RESPONSE TO INFORMATION REQUEST

DEVELOPMENT APPLICATION FOR A MATERIAL CHANGE OF USE – DEVELOPMENT PERMIT FOR EXTRACTIVE INDUSTRY AND ASSOCIATED ENVIRONMENTALLY RELEVANT ACTIVITIES AT LAND LOCATED ON PARADISE ROAD, CORINGA QLD 4621, PROPERLY DESCRIBED AS LOT 17 CK1566

NORTH BURNETT REGIONAL COUNCIL REFERENCE: DA230023

Figure 2 - AM Turn Warrant Assessment - Paradise Dam Rd / Booyal - Dallarnil Rd Intersection

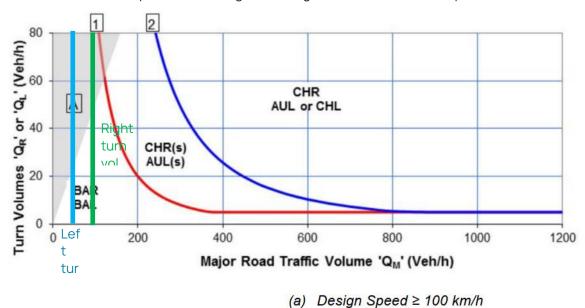
The nearest State Controlled Road that provides access to the site is Booyal – Dallarnil Road, some 16.77km distance from the site as determined by the NVHR Route Planner Tool. The below Table 1 presents the traffic census data for the nearest location to the intersection with Paradise Dam Road.

Given only the staff movements (7 in in AM and 7 out in PM peak hourly movements) will utilise the State Controlled Road network (arguably less with car-pooling), and conservatively assuming all in

movements are from the south (Biggenden or Childers via Isis Highway and Booyal-Dallarnil Road), turn warrant comparison has been completed – refer to Figure 2. The additional development volume on the State Controlled network accounts for less than 2% of the projected 2023 AADT. It is expected that this will be negligible in nature due to the relatively short duration of the project with the intersection capable of catering for turning traffic in excess of 80 vph as a BAR/BAL alone.

Figure 5 - Turn Warrant Assessment

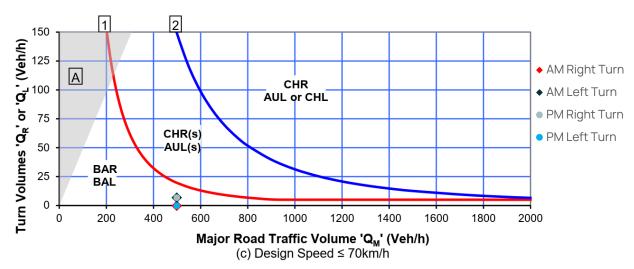
The intersection of Paradise Dam Road and Paradise Road is a three-way priority (give way) controlled intersection, with priority given to the Paradise Dam Road approaches. One lane in each direction of travel is provided on each approach to the intersection, with no turn treatments provided on any leg of the intersection.

A Turn Warrant Assessment has been carried out and it is recommended that a Basic Right-Turn Treatment (BAR) and Rural Basic Left-Turn Treatment (BAL) be provided at the intersection in accordance with Austroads Guide to Road Design Part 4A Section 7.5.1 and Section 8.2.1 respectively (Guide to Road Design Part 4A: Unsignalised and Signalised Intersections, 2021). Further information can be provided as part of an Operational Works Application (Roadworks). Refer to Figure .
